# PROPOSAL FOR CODE CHANGE

FOR OFFICE USE ONLY			
Received <b>12/14/2018</b>	Code <b>2018 IRC</b>	Proposal number <b># 362</b>	
Code title <b>International Residential Code</b>		Edition <b>2018</b>	
Section number and title <b>Table R301.2(1) Climatic and geographic design table</b>		Page Number	
Proponent <b>Bill Kaufholz</b>		Representing (if applicable) <b>Fischer Homes</b>	
Address (number and street, city, state, and ZIP code)		Telephone number	
PROPOSED CODE CHANGE (check one)			
<input checked="" type="checkbox"/> Change to read as follows <input type="checkbox"/> Add to read as follows <input type="checkbox"/> Delete and substitute as follows <input type="checkbox"/> Delete without substitution			
<p>Change the designations in the column "Ice Shield Underlayment required" to reflect "yes" or "no" designations currently listed in the 2005 Indiana Residential Code.</p>			
REASON STATEMENT AND FISCAL IMPACT			
<p>Reason: The IRC Review Committee approved proposal #33 (Wagner) as amended to require ice shield underlayment in every Indiana county. Indiana Builders Association supported the change 1) to help resolve conflicts between roofing companies, insurance companies, and h

FIGURE R703.8.6(1)

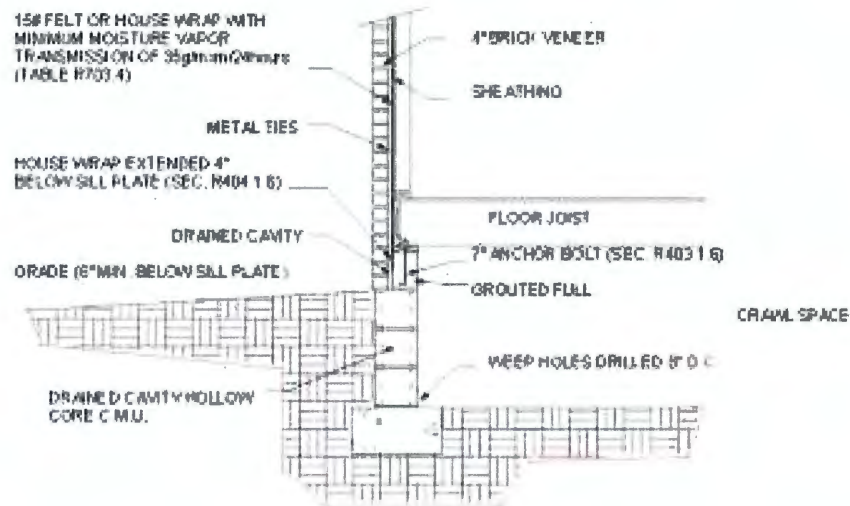
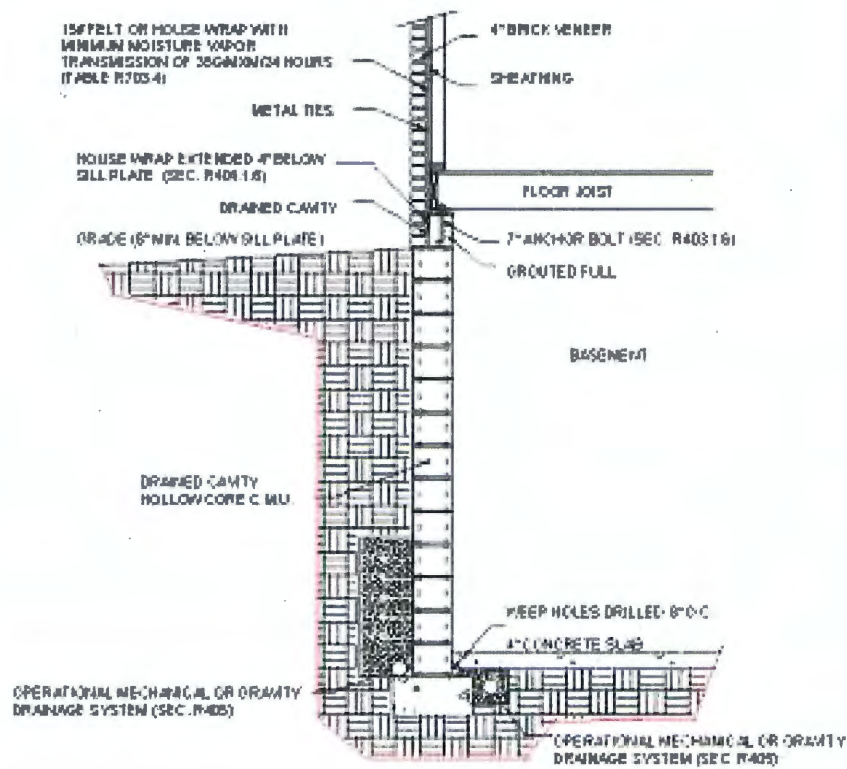
FOR OFFICE USE ONLY		
Received <b>12/14/2018</b>	Code <b>2018 IRC</b>	Proposal number <b># 368</b>
Code title <b>International Residential Code</b>		Edition <b>2018</b>
Section number and title <b>R703.8.6 Weepholes</b>		Page Number <b>376</b>
Proponent <b>Lynn Madden</b>	Representing (if applicable) <b>Hallmark Homes</b>	
Address (number and street, city, state, and ZIP code)		Telephone number
<b>PROPOSED CODE CHANGE (check one)</b>		
<input type="checkbox"/> Change to read as follows <input type="checkbox"/> Add to read as follows <input checked="" type="checkbox"/> Delete and substitute as follows <input type="checkbox"/> Delete without substitution		
<p>Delete the title and text of SECTION R703.8.6 and substitute as follows: R703.8.6 Drained cavity. The 3/4 inch (19 mm) air cavity shall be drained to the exterior of the structure at intervals of not more than 33 inches (838 mm) on center. Each drain shall be not less than 3/16 inch (4.8 mm) in diameter, located immediately above the flashing. For dwellings with crawl spaces, the air cavity may be drained as shown in FIGURE R703.8.6(1). For dwellings with basements, the air cavity may be drained as shown in FIGURE R703.8.6(2).</p> <p>Insert Figures R703.8.6(1) and R703.8.6(2).</p>

<b>REASON STATEMENT AND FISCAL IMPACT</b>		
<p>Reason: This proposal was rejected by the committee on 7/18/18, and therefore would require a 2/3 vote of the committee to reconsider. The Southwestern Indiana BA (SIBA) has submitted a support letter signed by home builders and 3 building officials requesting that the committee reconsider action taken on this proposal. SIBA members will be at the meeting on 12/19/18 to offer testimony in support of the proposal, which directly contradicts information shared at the meeting that builders in southern Indiana do not use this amendment, and to answer questions.</p> <p>Fiscal Impact:</p>		
<b>REVIEW RECOMMENDATION</b>		
Approve		
Reject		
Approve as amended		
Further study
